Service Advisory

CC-547

Models Affected: M48-KW (53AB5DBV750), M54-KW (53DB5DBW750), M60-KH (53CB5BDX750), M60-KW (53CB5D8X750), M60-KW ROPS (53CH5D8X750)

Subject: **Hydro Pump Pulley Retaining Nut Failure**

FIGURE 1

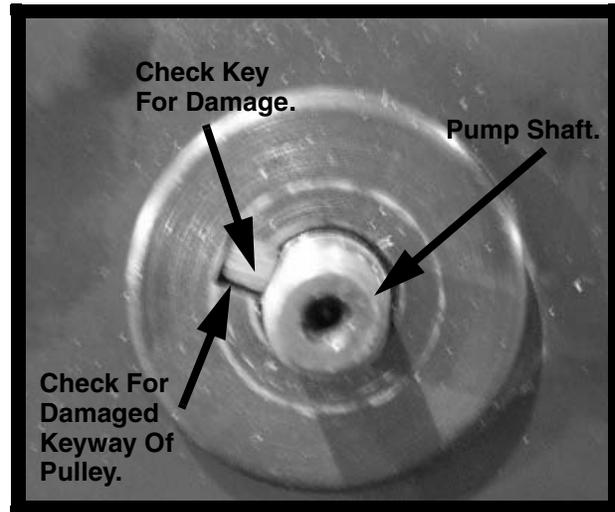
PURPOSE: The relationship between the taper of the drive pulley & shaft taper is such that the securing nut alone does not tighten the pulley to proper specifications. The pulley may loosen damaging the shaft, pulley & nut.

1. Park unit on a flat level surface.
2. Disconnect the negative battery cable from the battery terminal. Disconnect the positive battery cable from the battery terminal.
3. Lift unit high enough to check the pump pulley retaining nut.
4. Check the left pump pulley's for a flat washer between the nut & pulley.
5. Remove nut & washer if present and discard both.
6. Remove pulley. Inspect the key & keyway for any distortion from a loose pulley, Figure 1. If damage is evident replace key (**00020628**). Inspect the keyway in pulley for damage, install pulley, replace if needed.
7. Install flat washer (**00006168**) on top of pulley, then install the retaining nut (**01007309**). Torque the nut to 35 ft. lbs.
8. Repeat steps 4 through 7 for the right side pump pulley.

Order Per unit Quantity. (2) **01007309** Nut. Quantity. (2) **00006168** Flat Washer. Quantity. (2) **00020628** Key.
